Fire Risk Assessment

Property assessed: C Pasteur Court Nightingale Avenue London HA1 3GX
Client: Network Homes Ltd
UPRN: PAST0000-3
Property Classification: Level 1
Document Print Date: 21/04/2021

FRA Inspection Date: 20/08/2020
FRA Issued to Client: 21/10/2020
FRA valid to: 21/10/2021
FRA completed by: Savills (UK) Ltd,
33 Margaret Street, London W1G 0JD
T: 020 7409 8737
E: fireriskhousing@savills.com

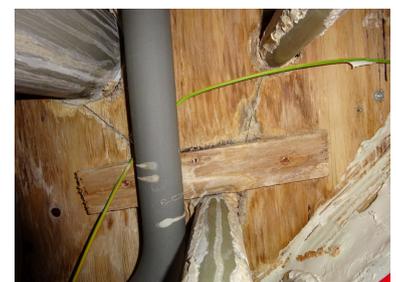
- Known	3		
- Potential	3		
Priority	B	Due Date: 21/10/2021	Client Status: Assigned
Question	Q.3	<p>Comment: The bedroom service riser cupboards on the ground, first and second-floors appear to have no internal lining provided within the cupboards and above the door. Network Homes confirmed previous recommendation is complete; to check all risers are suitably fire stopped - (All bedroom riser cupboards have been fire-stopped to the floor) The top floor bedroom riser cupboards have been fire stopped to the ceiling and above the door (Internally) to an adequate standard. Breaches were noted within the third-floor electrical cupboard (righthand side cupboard) to the wall to pipe egress.</p>	
Section	Limiting Fire Spread		
Action ID	544222		
Quantity		<p>Recommendation: The plasterboard panels and sections above/either side of the bedroom riser doors (Internally) where pipework and cables run to be fire stopped using fire-resisting materials to ensure 60 minutes of fire resistance between the cupboard and communal areas. Any fire-stopping works to be undertaken by a competent passive fire engineer.</p>

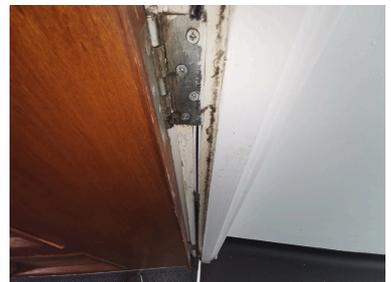
- Potential	22		
Priority	C	Due Date: 21/04/2022	Client Status: Assigned
Question	M.6	<p>Comment: The double doors to service/store cupboards do not have intumescent strips and cold smoke seals to the meeting stiles of the doors. Missing combined intumescent strips and cold smoke seals were also noted to 014 - Cluster kitchen door, 107-112 - Link door to Block B, 207-212 - Link door to block B and cluster kitchen 341. Cluster kitchens 340 and 141 were not accessible at the time of the assessment due to there being coded locks.</p>	
Section	Common Area Fire Doors		
Action ID	544225		
Quantity

- Known	15	<p>Recommendation: Common area fire doors as noted should be fitted with intumescent strips and smoke seals.</p>	
- Potential	15		
Priority	C	Due Date: 21/04/2022	Client Status: Assigned

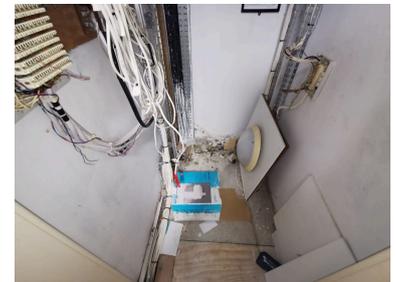
Comment: Previous recommendation - Discarded combustibles noted within a ground floor service cupboard CO5 and 2nd-floor service cupboard CO10 containing fixed electrical equipment.

Recommendation: All combustible items should be removed from the electrical intake cupboard as soon as possible and the door kept locked.

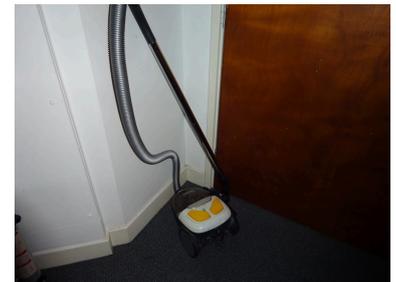
Comment: There were combustible items or waste materials in the escape routes. There was a cardboard box noted adjacent to C17. As the quantity involved is relatively minor this can be dealt with via written contact with the residents.

Recommendation: Management should contact residents to advise that the common area/escape routes should be kept free from all combustibles and/or trip hazards. A programme of regular checks should be put in place to ensure that the common area is kept clear.

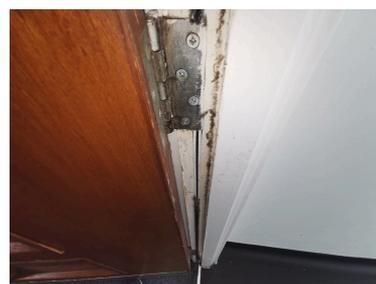
Comment: The double doors to service/store cupboards do not have intumescent strips and cold smoke seals to the meeting stiles of the doors. Missing combined intumescent strips and cold smoke seals were also noted to 014 - Cluster kitchen door, 107-112 - Link door to Block B, 207-212 - Link door to block B and cluster kitchen 341. Cluster kitchens 340 and 141 were not accessible at the time of the assessment due to there being coded locks.

Recommendation: Common area fire doors as noted should be fitted with intumescent strips and smoke seals.
